**New Hampshire Regional Haze Plan Periodic Comprehensive Revision
COMPILATION OF PUBLIC COMMENTS AND NEW HAMPSHIRE'S RESPONSES THERETO (2021-2022)**

EPA Comments on New Hampshire's April 19, 2021 draft New Hampshire Regional Haze Plan Periodic Comprehensive Revision Received August 3, 2021

EPA Comments on New Hampshire's December 5, 2021 draft New Hampshire Regional Haze Plan Periodic Comprehensive Revision Received February 25, 2022.

Figure 1: Merrimack Unit MK1 Full Operating Day NOx Emissions³⁰

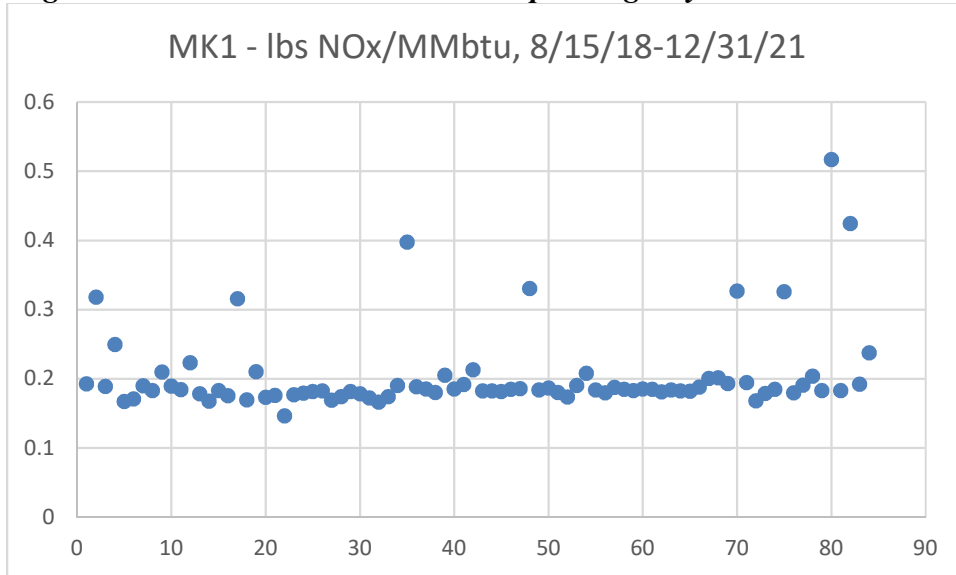
SC/AMC/NPCA/CLF Comment 1: Here, the proposed 0.22 lbs/MMbtu NO_x limits for the two Merrimack units are inconsistent with both RACT and Regional Haze requirements. First, such limits appear to be little more than improper rubberstamping of existing behavior at Merrimack....Nor is it necessary that DES allow Merrimack to emit greater quantities of NO_x at higher emission rates on the days in which a unit undergoes startup or shutdown. Notwithstanding the theory that lowered control inlet temperatures during startup and shutdown necessitate bypassing the SCR, recent information shows that SCR controls can in fact be operated at low-temperature levels with no detriment to control efficacy or longevity.

little more than improper rubberstamping of existing behavior at Merrimack. Figures 1 and 2 below look at the NOx emission rates for both Merrimack units on operating days reporting 24 hours' worth of operations (thereby excluding startup and shutdown periods). As can be seen, with the exception of some excursions at MK1, and even more excursions at MK2, both units seem to comfortably keep their 24-hour NOx emission rates at or below 0.20 lbs/MMbtu—roughly 10% below the limit. Indeed, MK2 keeps its daily NOx emission rate below 0.19 lbs/MMbtu half the time, and MK2 manages to keep its daily NOx emission rate below 0.185 lbs/MMbtu half the time.

NHDES Response: NHDES recognizes that NO_x emission rates for various coal facilities across the country are on average lower than the rates for the units at Merrimack Station, however NHDES has met the requirements outlined for setting RACT standards as well as the regional haze rule. The commenter notes that RACT is defined as "the lowest emission limit that a particular source is capable of meeting by the application of control technology that is reasonable available considering technological and economic feasibility." Also, "RACT for a particular source is determined on a case-by-case basis, considering the technological and economic circumstances of the individual source."⁶ Given this criteria, NHDES selected RACT for Merrimack's MK1 and MK2 units station based on comparison to similar cyclone boiler units that operate SCR controls on a year-round basis. The Merrimack units have unique characteristics including higher NO_x levels generated by high operating temperatures and the challenge of balancing efficient

Figure 3: Merrimack Plantwide NOx Emission Rate, 2015-2021³²

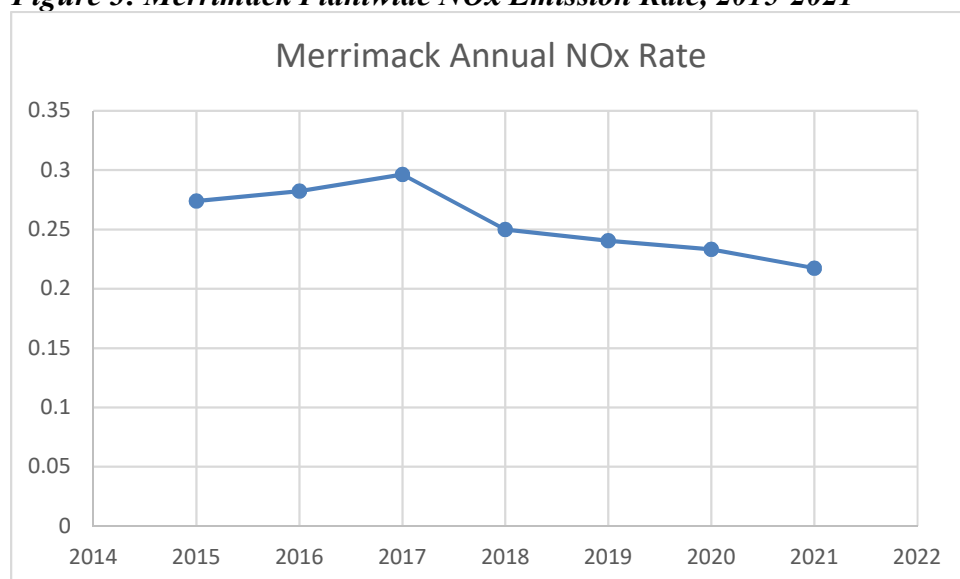
86 Fed. Reg. 23,054, 23,088 (April 30, 2021) (emphasis added). By way of comparison, Merrimack, on an annual, plantwide basis, comes in at emission rates of roughly *triple* what EPA presumes such SCR-equipped units should be able to achieve.

Indeed, as a comparison of Figures 1 and 2 on the one hand and Figure 3 on the other demonstrates, Merrimack’s extraordinarily high NOx emission rates appear to have little to do with increased startup and shutdown cycling as its capacity factor has decreased over time; Merrimack appears to operate such that even when using its SCR controls, it comes in just under the limit that DES has imposed.

Figure 4: Schiller Coal Unit NOx Emission Rate, 2015-2022³⁴

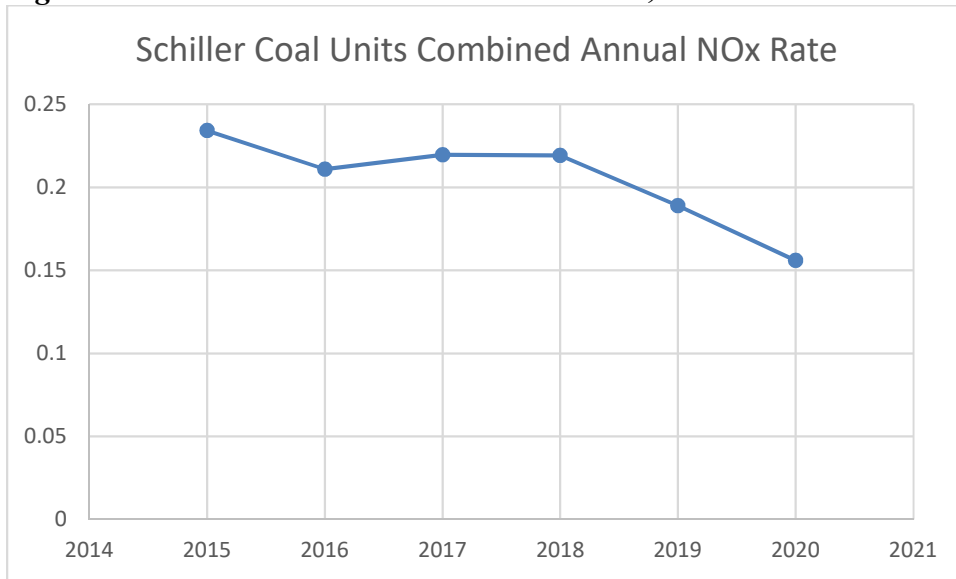
years, Schiller’s two coal units combined have achieved a *better* annual NOx emission rate than Merrimack has.

Figure 5: Merrimack Annual Operations, 2015-2021³⁸

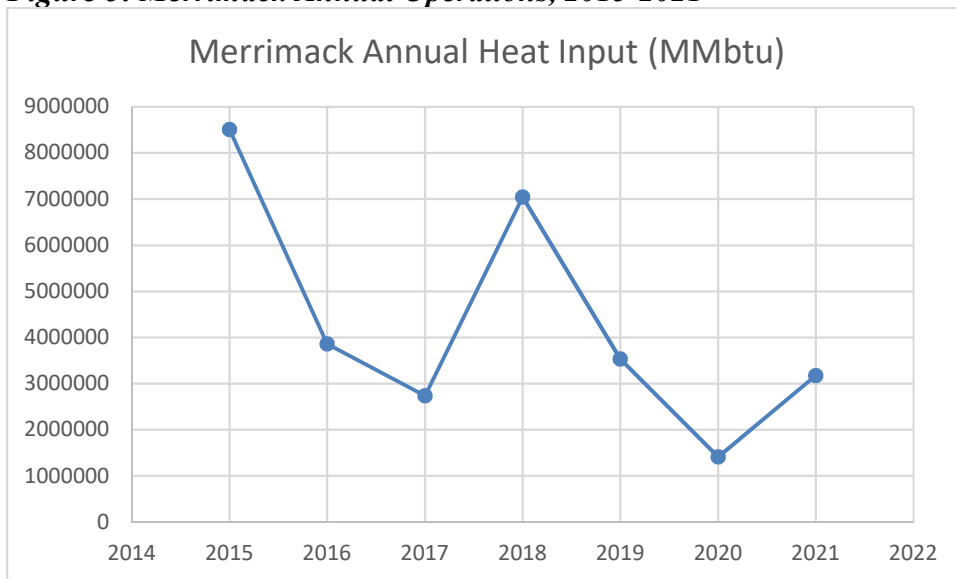
However, there is no guarantee that 2020 (an aberrant year because of the COVID-19 pandemic) represents a permanent new normal at Merrimack; Merrimack’s operations appear to swing wildly, with heat input more than doubling from 2017 to 2018, and more than doubling again from 2020 to 2021. Unsurprisingly (given Merrimack’s lackluster NOx control operation), Merrimack’s total NOx emissions have matched this operational profile:

Figure 6: Merrimack Annual NOx Emissions in Tons, 2015-2021³⁹

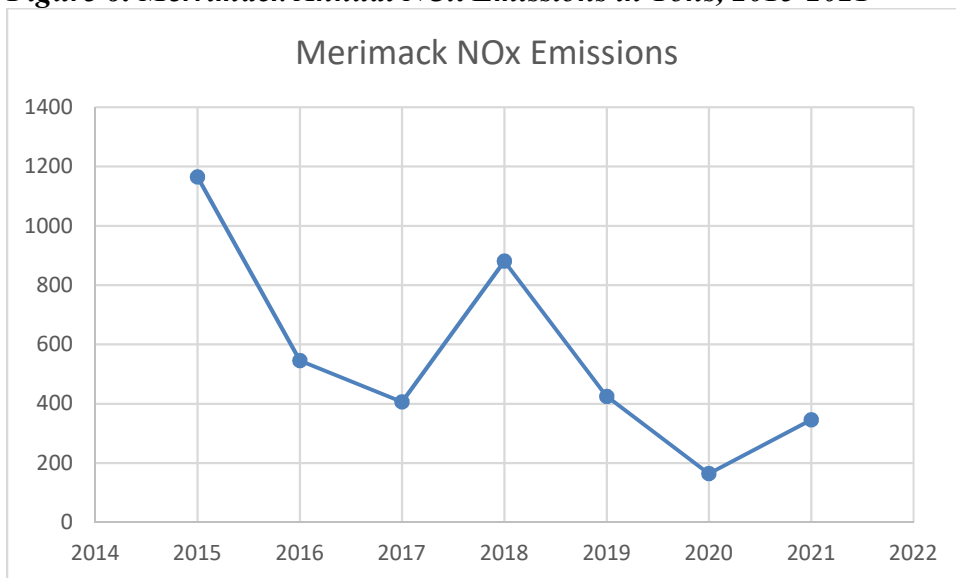
Accordingly, while total NOx emissions may be down for the moment from Merrimack, nothing prevents them from rebounding to higher previous levels—Merrimack could continue to comply with the very generous 0.22 lbs/MMbtu NOx emission rate that DES proposes while

dramatically increasing overall NOx emissions if Merrimack simply returned to pre-pandemic levels of operation.

Figure 7: Schiller Coal Units Annual NOx Emissions in Tons, 2015-2021⁴⁰

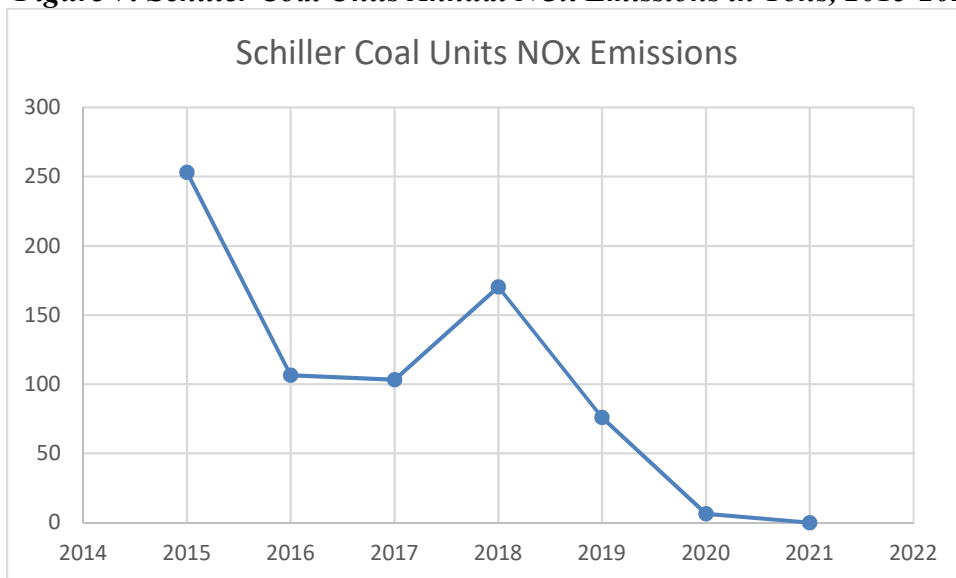
The situation at Schiller is similar. While during the pandemic years of 2020 and 2021, Schiller's coal units emitted very little NOx, it was averaging well over 100 tons per year just before that.

Absent any requirement to curtail operations, Schiller could quickly return to this high-NOx emitting status whenever its operators decide to increase operations again. As DES recognizes:

Figure 1. Contribution of All Sources to GGPRDR Wilderness Areas from Sulfate and Nitrate (Mm-1)

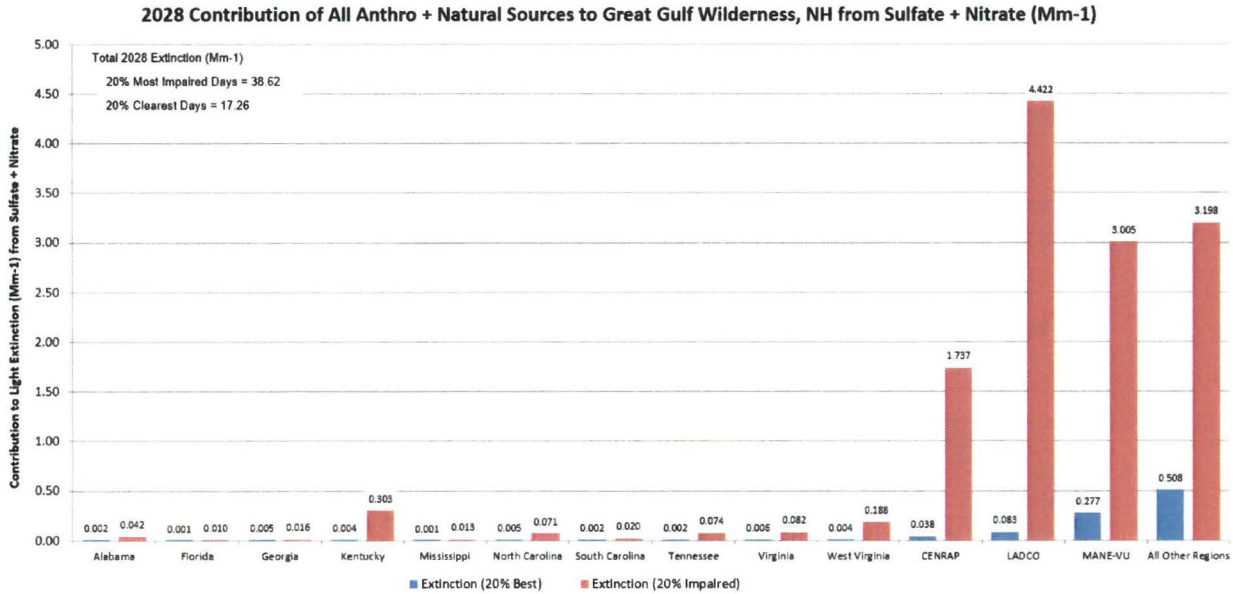
Relative to the screening methodologies used by MANE-VU, photochemical grid and source apportionment models are regarded as superior to other techniques like Q/d and CALPUFF for determining statewide contributions because the models account for meteorological conditions and photochemistry over long distances that are not fully addressed by the screening methodologies. In addition, state contributions to visibility impairment in Class I areas should be calculated for 2028, not 2015, to allow states to coordinate regional haze planning with other regulatory programs including, but not limited to, the 2010 1-hour SO₂ National Ambient Air Quality Standard (NAAQS), the 2012 annual PM_{2.5} NAAQS, the 2015 8-hour ozone NAAQS, and the Mercury and Air Toxics Standards (MATS) rule.¹¹ This point is supported by EPA’s regional haze guidance which recommends the use of 2028 year emissions for calculating baseline visibility impacts before selecting sources for further analysis.¹²

The DAQ believes that use of photochemical and source apportionment models such as CAMx/PSAT provide a much more accurate estimate of statewide contributions to visibility impairment in Class I areas than the screening methodologies used by MANE-VU to identify contributing states. Given the VISTAS modeling results, NC’s contribution to visibility impairment to the GGPRDR Wilderness Areas is well below the 2% threshold established by MANE-VU and; therefore; the DAQ requests that NC be removed from NH’s list of states considered to be reasonably attributing to visibility impairment at the GGPRDR Wilderness Areas.

Figure 1: Quarterly NOx Emission Rates at Schiller Units 4&6, 2010-Present¹²

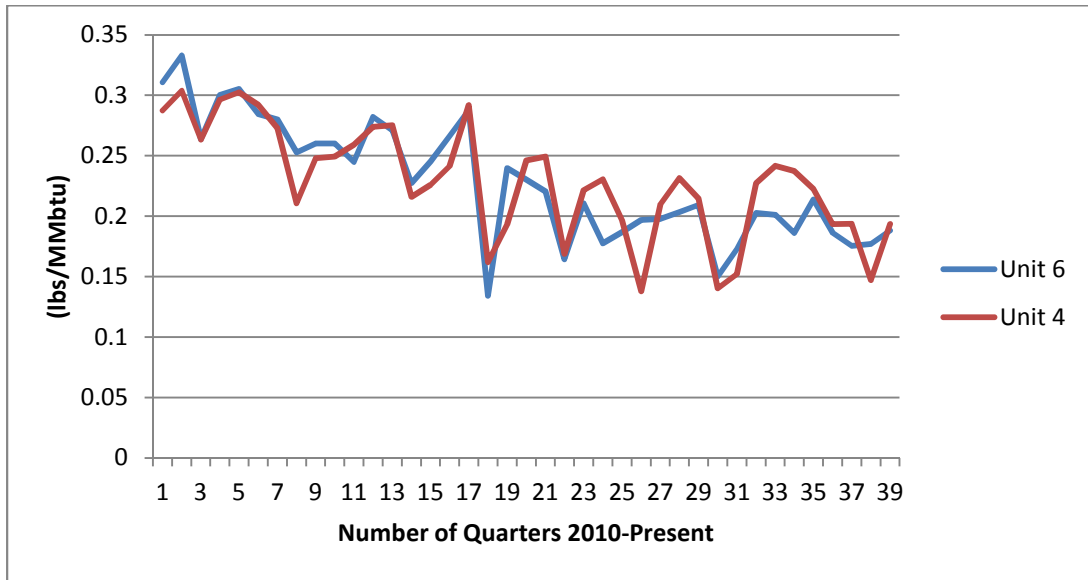
As Figure 1 demonstrates, both Schiller coal-fired units have recently averaged NOx emission rates well-below 0.25 lbs/MMbtu.

In fact, for the past four quarters, both units have had emission rates below 0.20 lbs/MMbtu (or 20% below the contemplated limit) and both units have in the past decade achieved multiple quarters with emission rates below 0.15 lbs/MMbtu (fully 40% below the contemplated limit). What this means is that Schiller could increase its NOx emission rates quite dramatically—to the detriment of visibility in New Hampshire—while still being in compliance with the emission limit contemplated in the Draft Revision. This problem is exacerbated by the fact that the Draft Revision does not contemplate an overall mass limit for NOx emissions, and relying instead on a simple emission rate limit; increased operation at Schiller could result in further increases in the amount of NOx emitted even if Schiller were still “compliant” with the Draft Revision’s proposed emission limit.

Figure 2: Schiller Station NOx Emissions versus Emission Rate, 2007-2018¹³

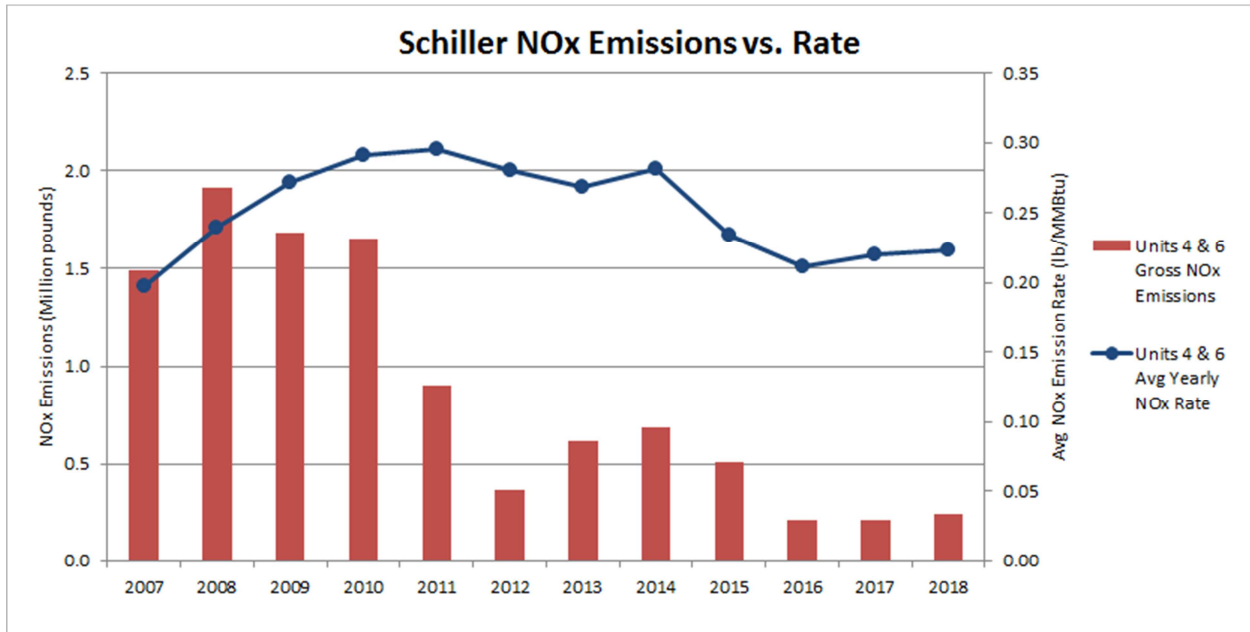
This is particularly problematic given that so much of the visibility gains cited by DES in the Draft Revision are due to unenforceable factors, such as economic redispach from more pollution-intensive electricity generators to cleaner sources. These gains are therefore at risk of being reversed.
